PARTS LIST

SERVICE CHANGES

T/I#DT162

1. Changes on

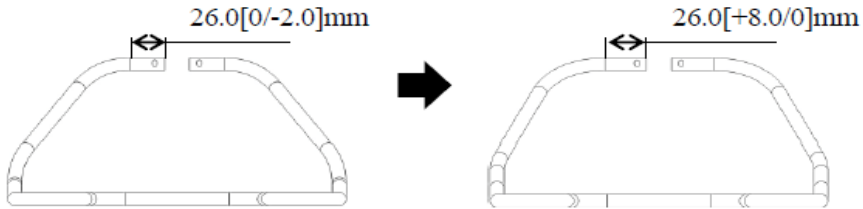
Item No.	Description	Type 1	Type 2
30	STAND	327C17-9	327D98-9
15	HARNESS PLATE ASSY	137125-8	137153-3

Above parts are completely interchangeable as a set.

The shapes of Stand and Harness plate will be changed as follows:

Stand: The shape will be changed to improve assemblability with Stand holder U.

Harness plate: The shape will be changed so as not to interfere with Stand.
